LINCOLN PARK PLANNING COMMISSION

Site Plan Review

Applicant	Clearwave Management, LLC
Project	Car Wash
Address	3727 Dix Hwy. Lincoln Park, MI 48146
Date	April 14, 2021
Request	Site Plan Review
Recommendation	Approval with Conditions

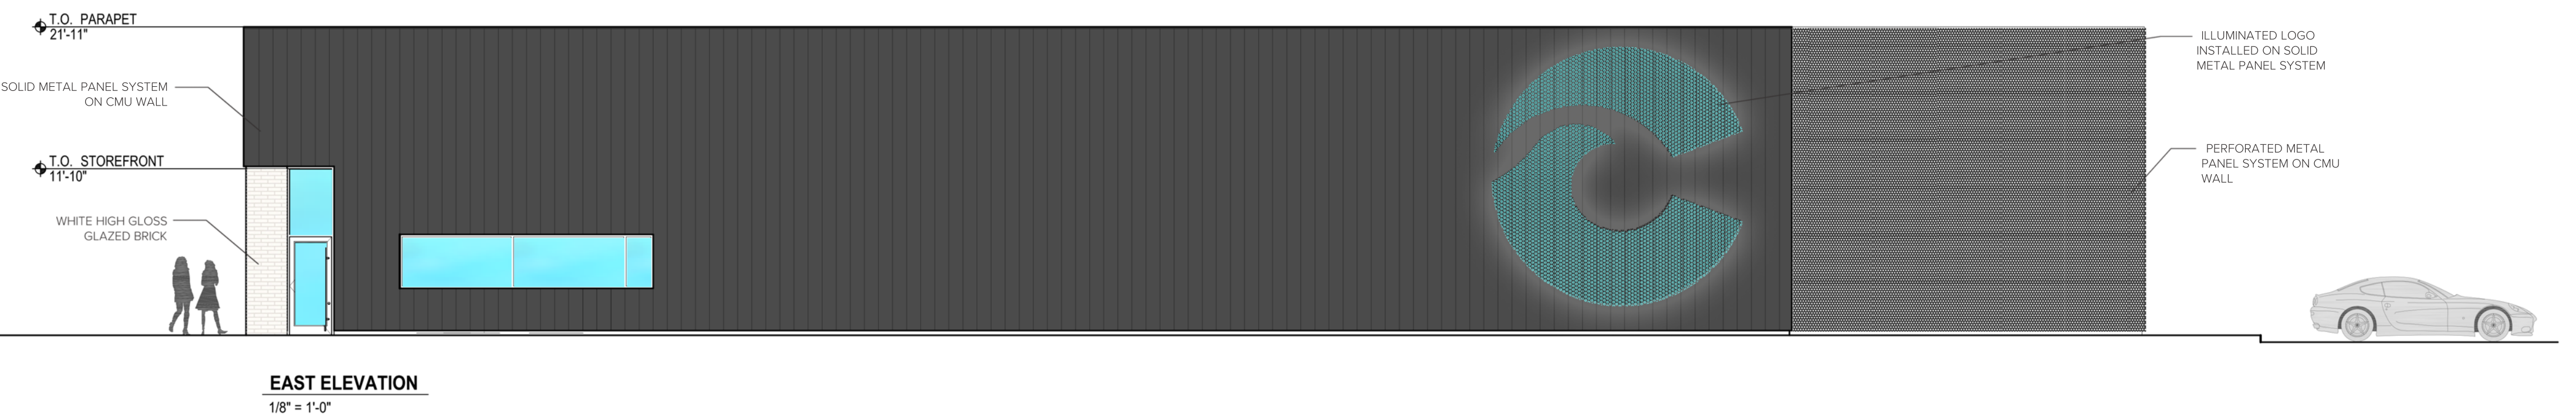
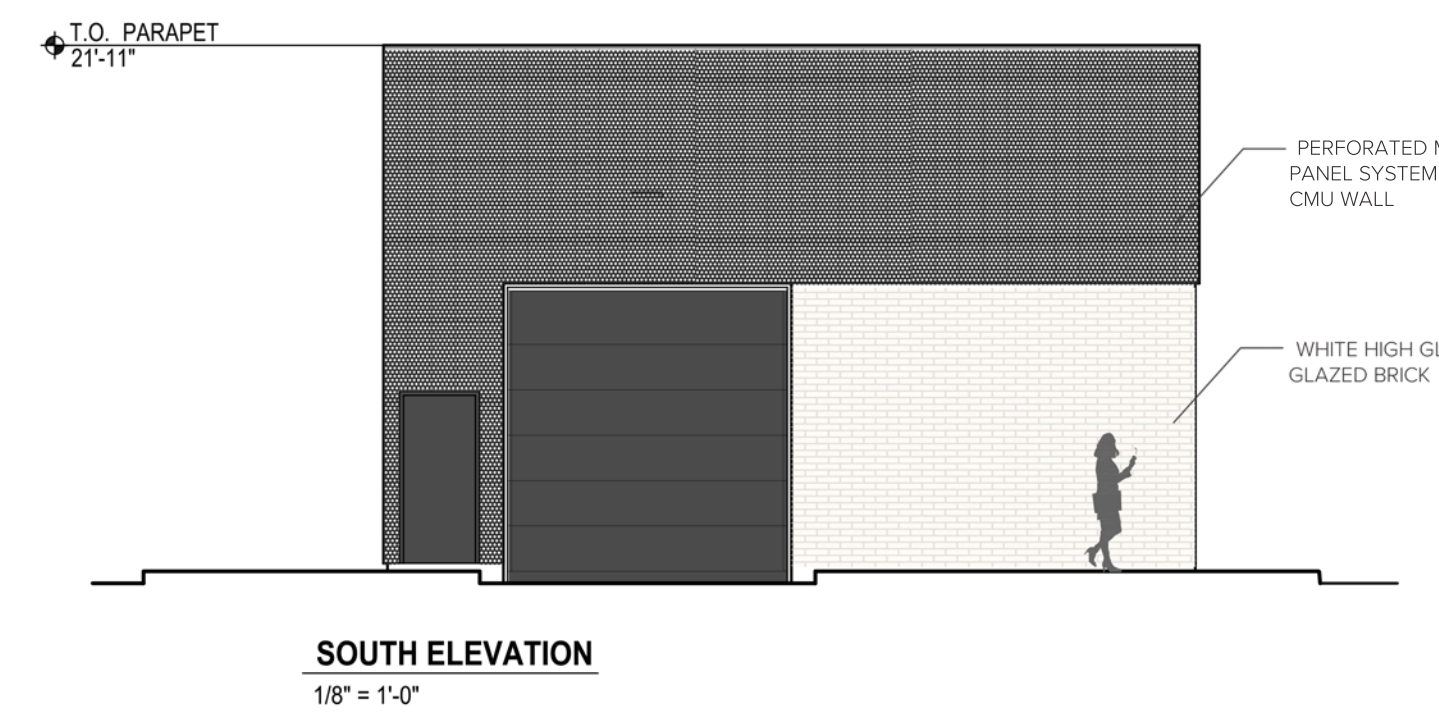
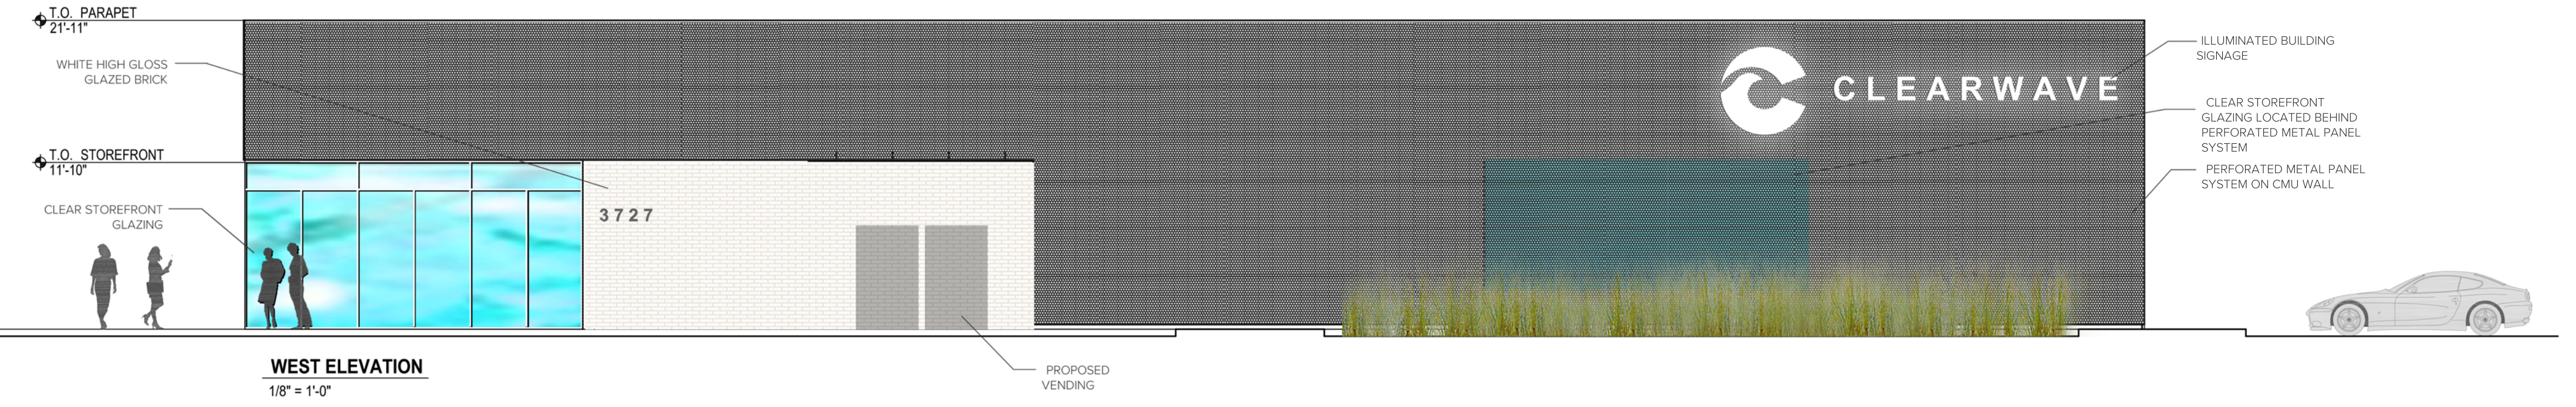
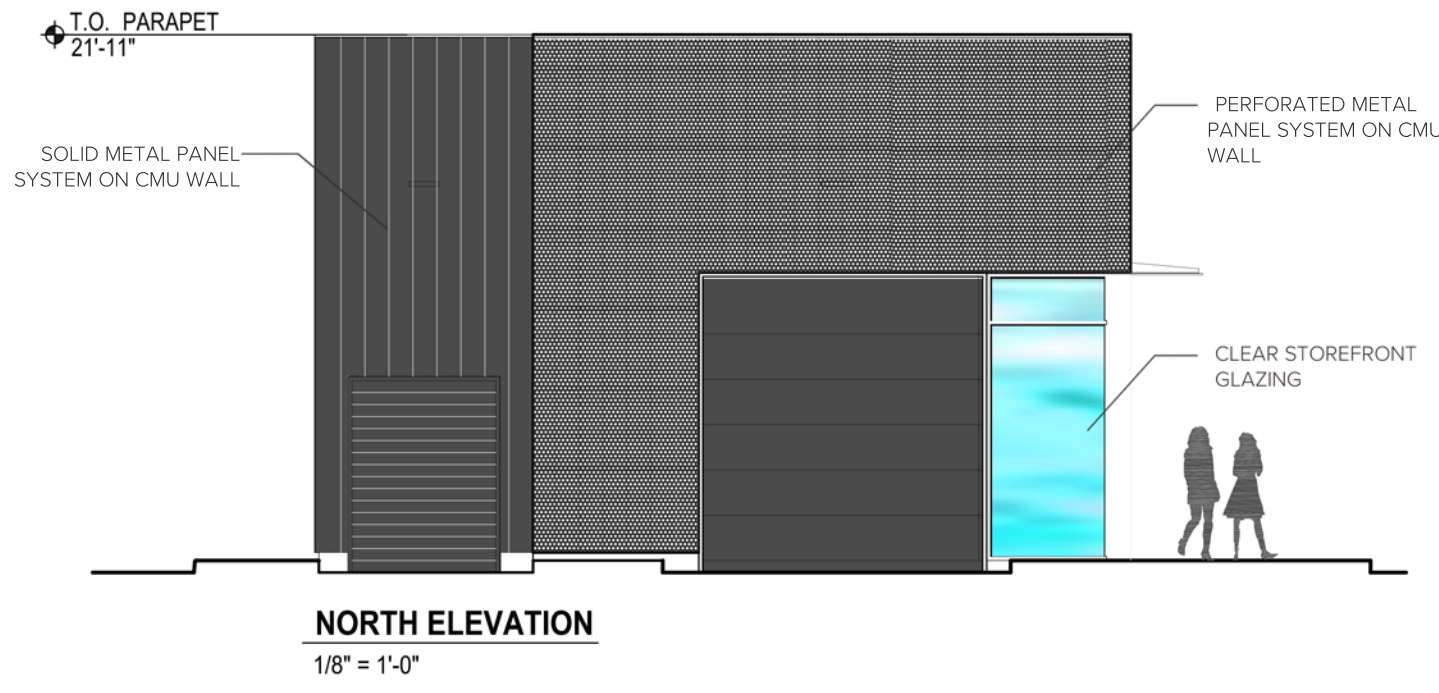
- Applicant shall revise façade to comply with transparency percentage requirements.*
- Planning Commission to consider applicant preference for a flat roof with "clean lines" over ordinance requirement for roof form embellishment.*
